August 11, 2020

**Re: Proposed Chase Bank – 1574 Woodbury Avenue - Site Plan Review**

**RE: Waiver Requests for Site Plan Review – 1574 Woodbury Avenue  
Proposed Chase Bank (at former Ruby Tuesday's)**

**SHEET NO.**  
**C-2**

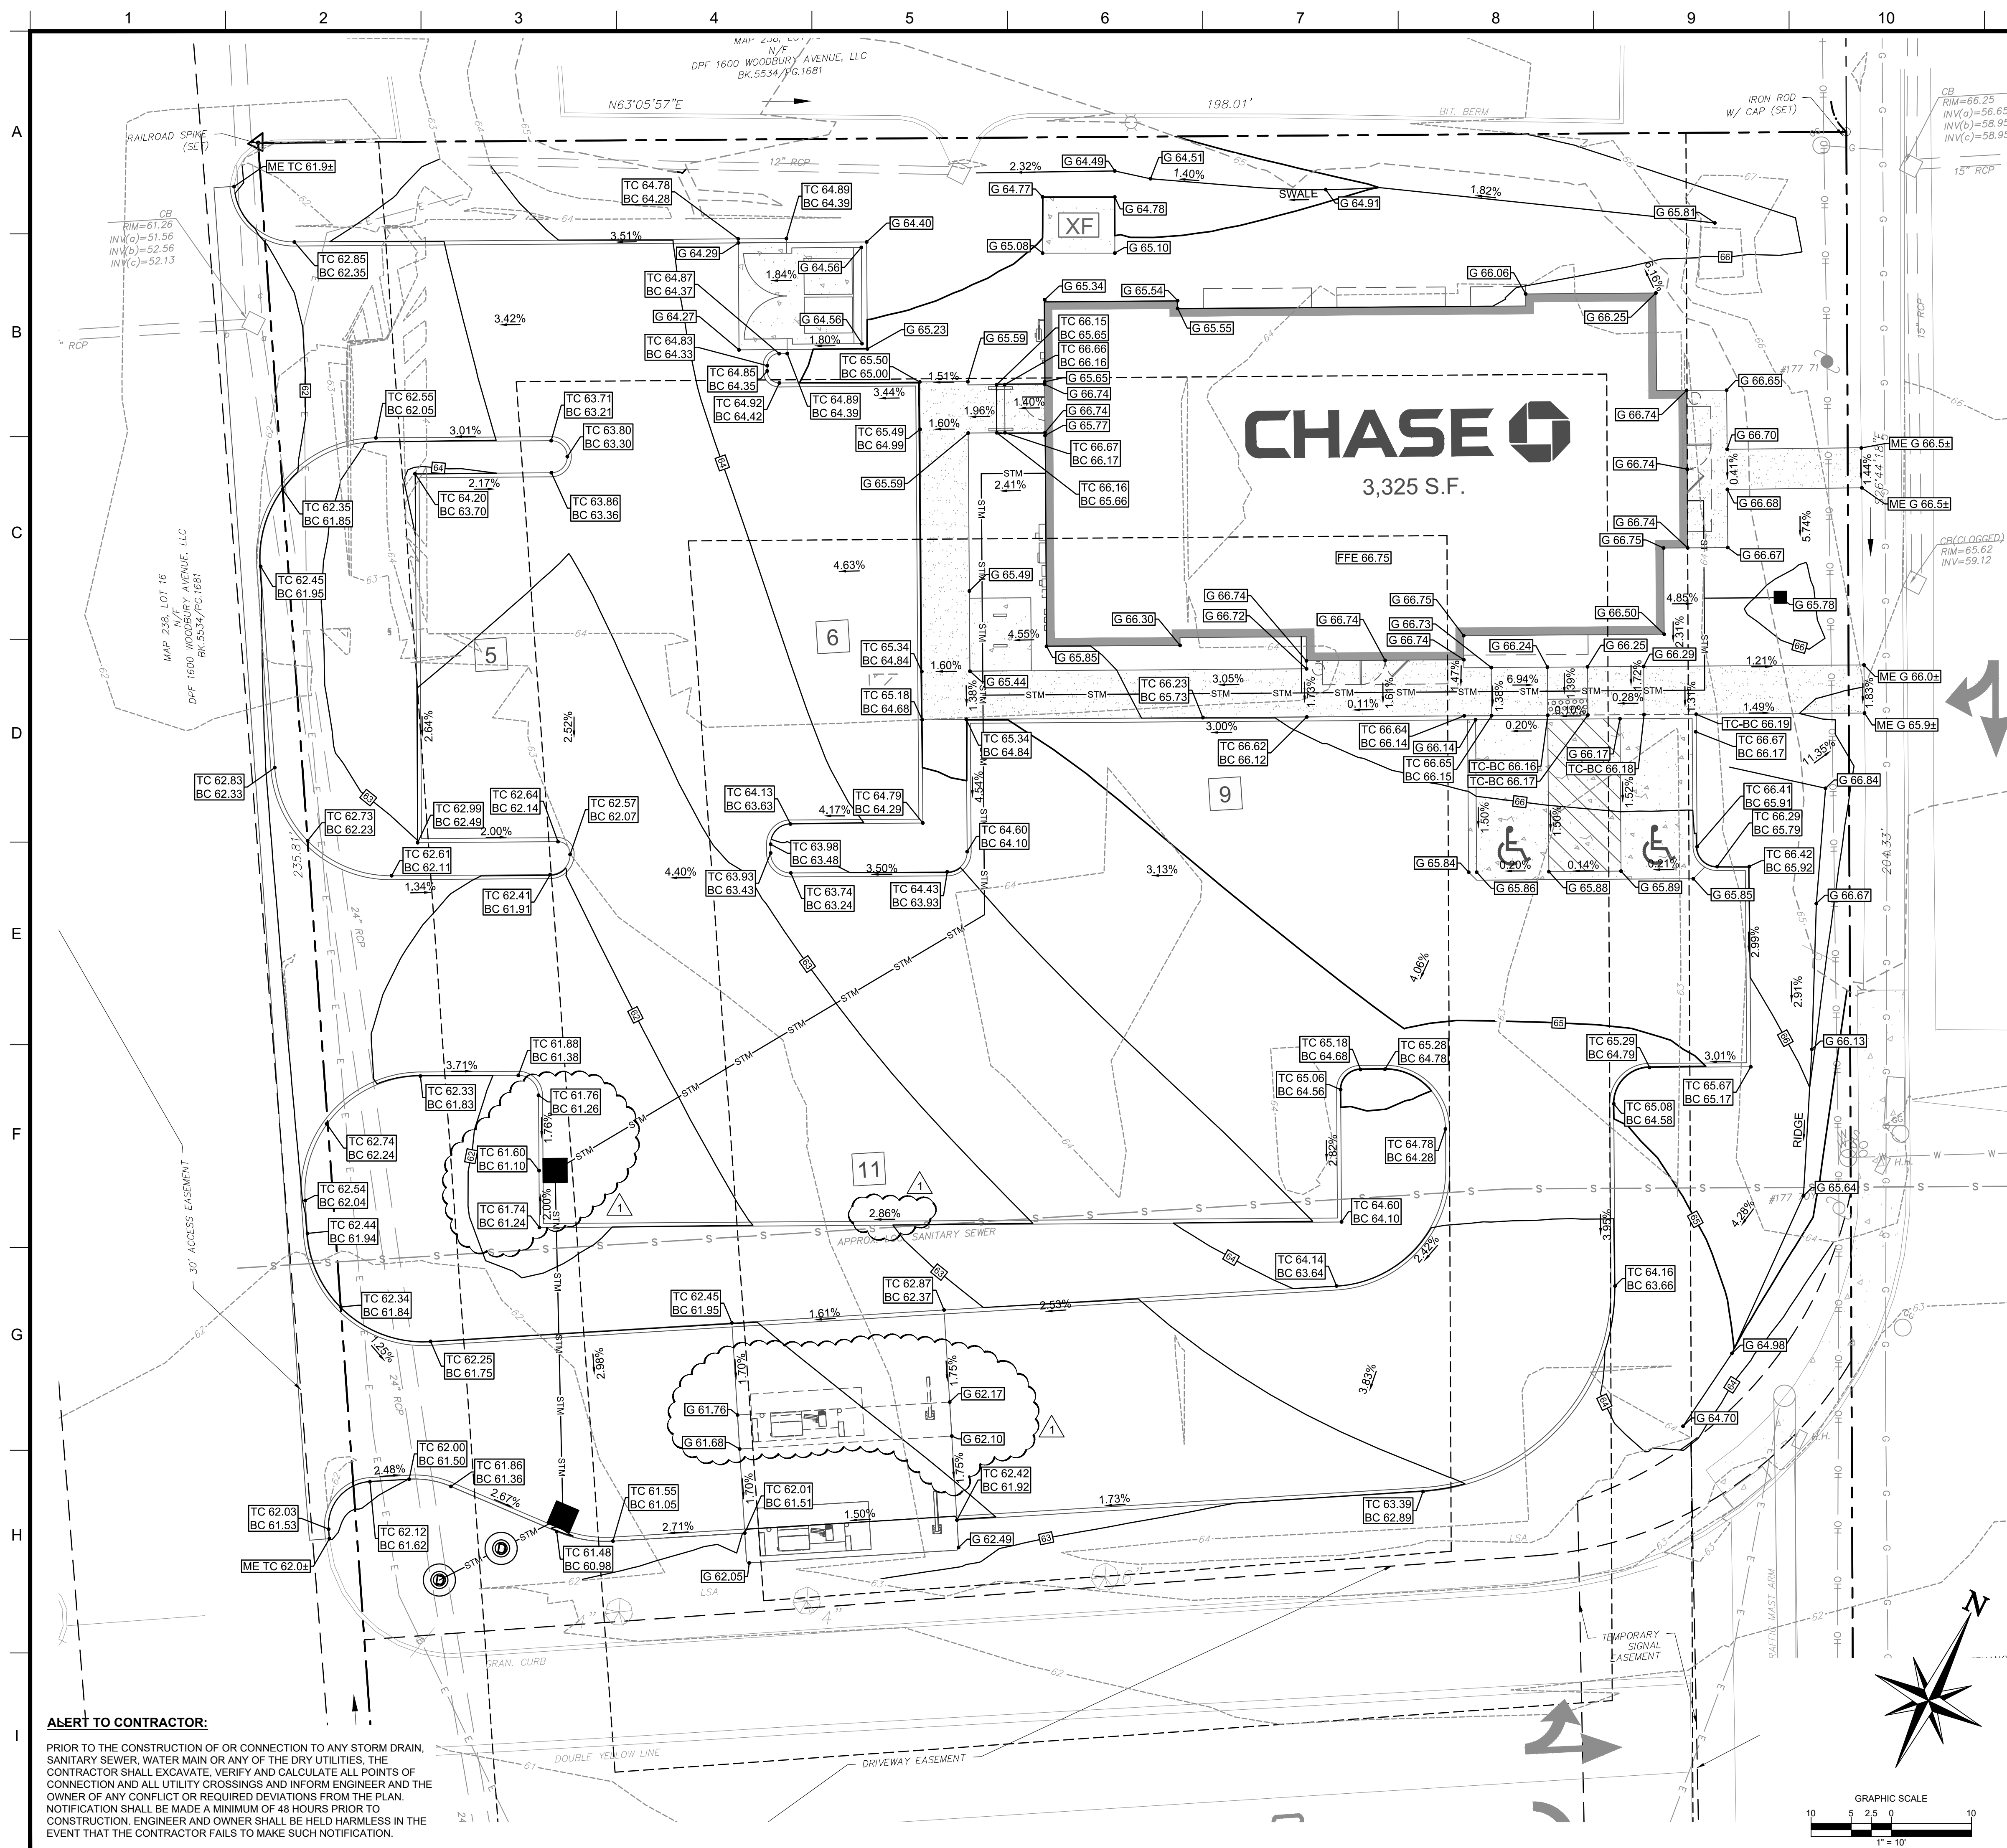
1. Move notes 1-3 on Cover Sheet to sheet C-2 – these are required to be included on the site plan sheet that will be recorded.  
*Relocated as requested.*

5. On Sheet C-2, please add a note that a separate sign permit will be required for any proposed signage listed in the "Signage Table"

*Added as requested.*

NOTE: A SEPARATE SIGN PERMIT WILL BE REQUIRED FOR ANY PROPOSED SIGNAGE LISTED IN THE SIGNAGE TABLE.

C-4

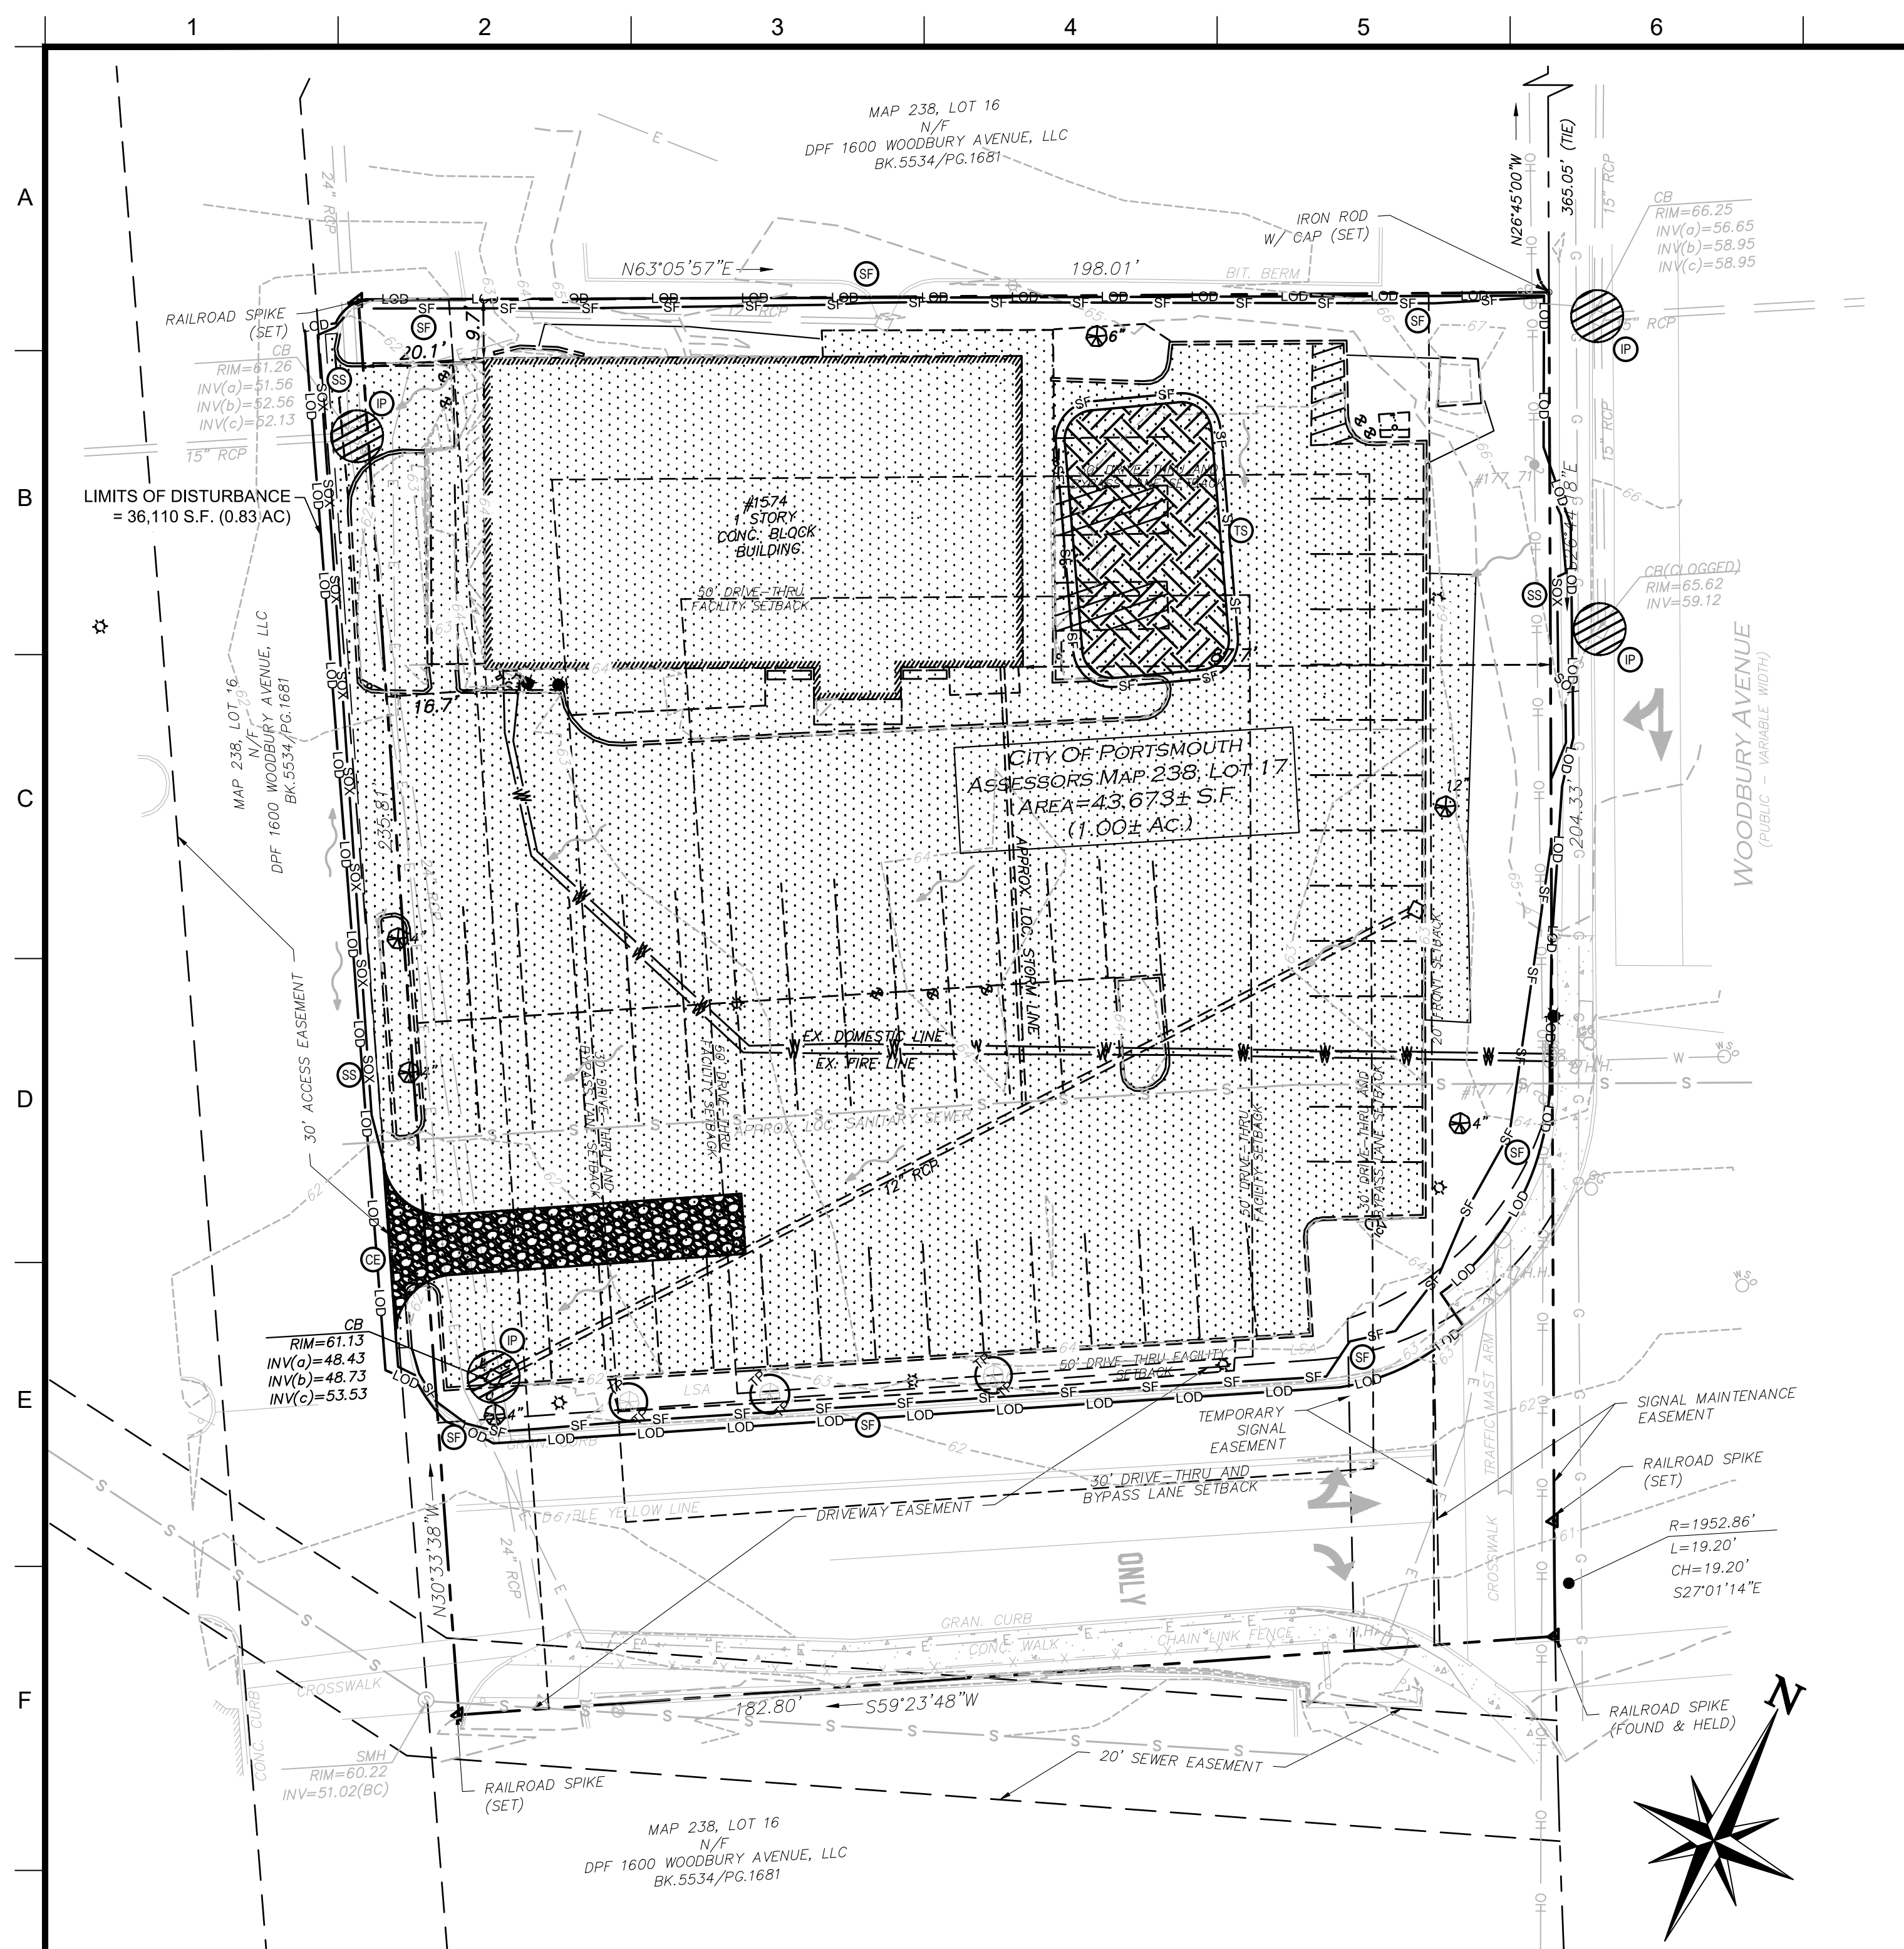
8. What are the dimensions of the proposed bike rack pad and how far is it from the building?  
*Dimensions shown on the updated plan. Please refer to Sheet C-4.*
